To: James Steckel, NRC
From: June Sevilla
Subject: Request NRC action on Plausible Earthquake Fault at Calvert Cliffs - scientific information for CC3 FSAR consideration, Docket No. 52-016
SRP Section: 02.05.04 - Stability of Subsurface Materials and Foundations
Application Section: 2.5.4

Request for Additional Information No. 218 (eRAI 4332) DRAFT

Calvert Cliffs Unit 3 UniStar

Docket No. 52-016
SRP Section: 02.05.04 - Stability of Subsurface Materials and Foundations
Application Section: 2.5.4

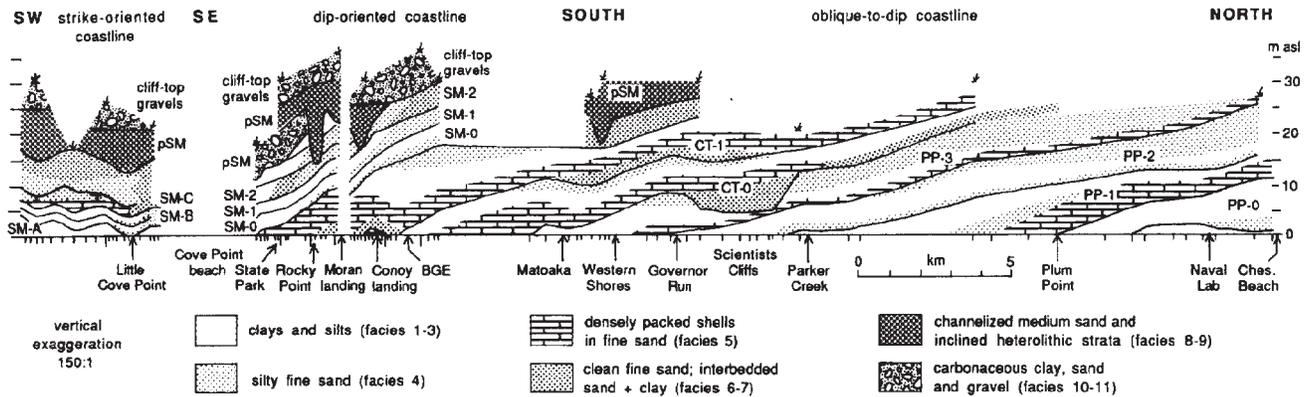
Vogt has raised concerns regarding the possible existence of a geological fault line located in the vicinity of the CCNPP. An indication of the fault along the cliffs south of the power plant is apparently suggested in a scientific paper by the paleontologist Susan Kidwell of the University of Chicago published in 1997. It would be extremely difficult for anyone other than a professional in her field to ascertain that she might be discussing a geological fault exposed in the cliffs. Dr Kidwell calls our attention to an area of the cliffs where offsets in the stratigraphic sequence of beds are indicated. While she does not specifically state it, such offsets commonly indicate breaks in sedimentary beds, possibly due to faults or perhaps significant folds in the original orientation of the beds. Vogt has helped to define this work by noting that the exposure is approximately 1 ¼ miles south of the power plant at a site called Moran's Landing. I am not familiar with this site, but it appears to be located near the mouth of a stream called Thomas Branch in the Calvert Cliffs State Park. It will help you to visualize the probable fault location by using Google Earth and focusing on the state park. Click on some of the blue squares along the parks shoreline until you find one labeled Thomas Branch. At this point you will see two streams that intersect near the beach. One has a NE/SW trend while the other trends NW/SE. If you back out enough to change the scale of the photo image to see St. Leonard Creek to the west, you will also see a cove at Vera's marina at White Sands. It has the same NW/SE trend and apparently connects with the ravine with the same trend at Thomas Branch. Such erosion patterns often reflect underlying zones of weakness in the underlying sediments. In some cases this erosion occurs along fault planes (these are really common in California, for example). In other cases it might occur in anomalies in the underlying sediments. A good example would be erosion of a buried stream channel. Linear erosion patterns are more suggestive of underlying fractures.

RE JSR paper: In addition to the cross-section, which speaks for itself, there's a section on p.324 labeled "Modification of original dip" that will be of interest. The section on the SM-O disconformity will also be of interest, including the subsection "alternative stratigraphic interpretations" and "biostratigraphic corroboration". These spell out the reasoning as well as highlight the data supporting the SM-0 surface as the key discontinuity in this part of the record.
